UNITED STATES
NUCLEAR REGULATORY COMMISSION
WASHINGTON, D.C. 20555-0001

SUBJECT: COMANCHE PEAK NUCLEAR POWER PLANT, UNITS 1 AND 2 – SAFETY EVALUATION REGARDING IMPLEMENTATION OF MITIGATING STRATEGIES AND RELIABLE SPENT FUEL POOL INSTRUMENTATION RELATED TO ORDERS EA-12-049 AND EA-12-051 (CAC NOS. MF0860, MF0861, MF0862, AND MF0863)

Enclosure:
Safety Evaluation

Figure 1 - Comanche Peak SFP Levels of Monitoring

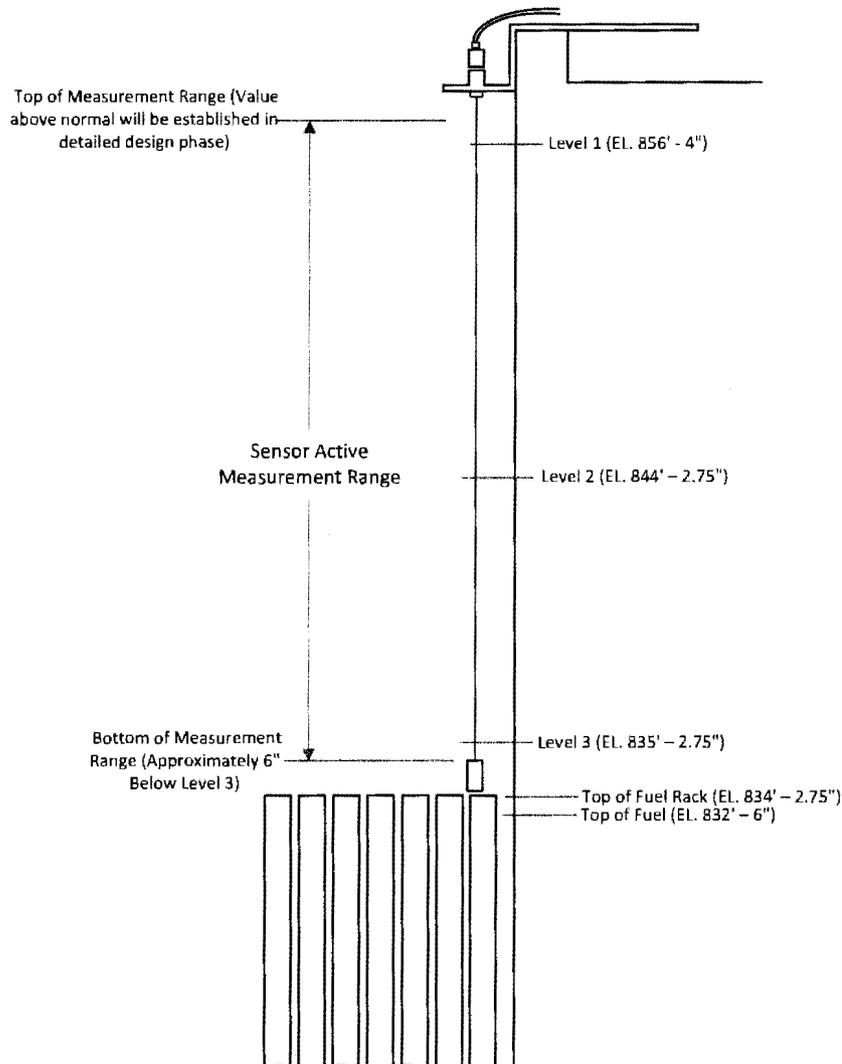
In its letter dated July 3, 2013 [Reference 24], the licensee stated that Comanche Peak designated Level 1 to be Elevation 856'-4" (22'-1.25" above the top of the fuel racks). This level corresponds to the LO-LO [low-low] level process setpoint that trips the fuel pool cooling pump as described in Comanche Peak UFSAR, Section 9.1.3.2. The LO-LO level process set point is selected to ensure that the pump will trip prior to a point where a void will occur in the suction lines. The licensee's analysis has demonstrated that there is adequate NPSH [net positive suction head] for pump operation at saturated conditions for water at plant elevation 856'. In its letter dated July 3, 2013 [Reference 24], the licensee also provided a sketch depicting Levels 1, 2, and 3 and SFP level measurement range as shown in the figure below (Figure 1 - Comanche Peak SFP Levels of Monitoring).

As discussed in NEI 12-02 [Reference 8], Section 2.3.1, Level 1 will be the HIGHER of two points. The first point is the water level at which suction loss occurs due to uncovering of the spent fuel cooling inlet pipe. The second point is the water level at which loss of spent fuel cooling pump NPSH occurs under saturated conditions. The NRC staff determines the designated Level 1 (856'-4") is the HIGHER of the above two points and therefore consistent with NEI 12-02 [Reference 8]. Level 2 was identified as elevation 844'-2.75". The NRC staff has determined this level is consistent with NEI 12-02 [Reference 8], since it is 10' ($\pm 1'$) above the highest point of any fuel rack seated in the SFP. Finally, the NRC staff found that Level 3 (835'-2.75") is consistent with NEI 12-02 [Reference 8] Level 3, since it is above the highest point of any fuel rack seated in the SFP.

As for the SFP level measurement range, the licensee stated that the primary and backup instrument channels will provide continuous level indication over a range of 23'-9.25", from 12" above the top of the fuel storage racks (plant elevation 835'-2.75") to the high pool level elevation (plant elevation 859'). In its letter dated July 3, 2013 [Reference 24], the licensee provided a sketch depicting the SFP levels of monitoring and the instrument measurement ranges (Figure 1 of this evaluation).
